FTI-STP1 Automatic Transmission Application Bulletin/Advisory F RSTECH

Overview: The **FTI-STP1** harness may require modification for use in **automatic transmission (AT)** applications, some of the product was able to be modified before release, but a small quantity was released before being able to be modified internally.

Overview: Production error; immobilizer wire (orange/black) in pin position #4 instead of pin position #5. Although an effort to correct the issue was made, some quantity of harnesses did get shipped before the issue was spotted. We are advising to inspect the harness BLADE connector before attempting to install the harness and program the module.

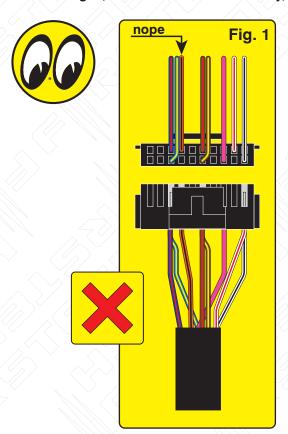
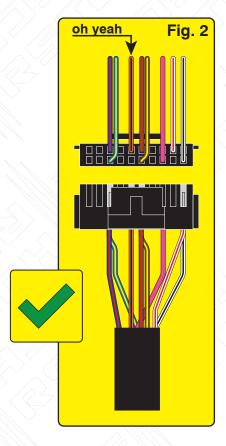
ISSUE: Module fails to program to vehicle, will not allow the vehicle to be remote started.

Correction: Step 1.) Locate the orange/black wire and confirm whether it is positioned as illustrated in Fig. 1 or Fig. 2. If the wire is as illustrated in Fig.1, proceed with Step 2 through 5 and complete the repair procedure outlined, if the wire is as illustrated in Fig. 2, correction is not necessary, proceed with harness installation and module programming.

- Step 2.) Using a pick, lightly depress the catch that secures the terminal in the housing then remove the wire and terminal from the housing.
- Step 3.) Using a fine tip razor or utility knfe, inseret the blade beneath the terminal catch and raise it slightly, so that it can be reused to secure the terminal when reinserted into the BLADE connector housing.
- Step 4.) Refer to Fig, 2 for correct position of the orange/black wire (next to brown/red) then reinsert the terminal, pressing lightly until the catch 'snaps' into place, securing the terminal in the connector housing.
- Step 5.) The repair is complete, proceed with installation and programming.
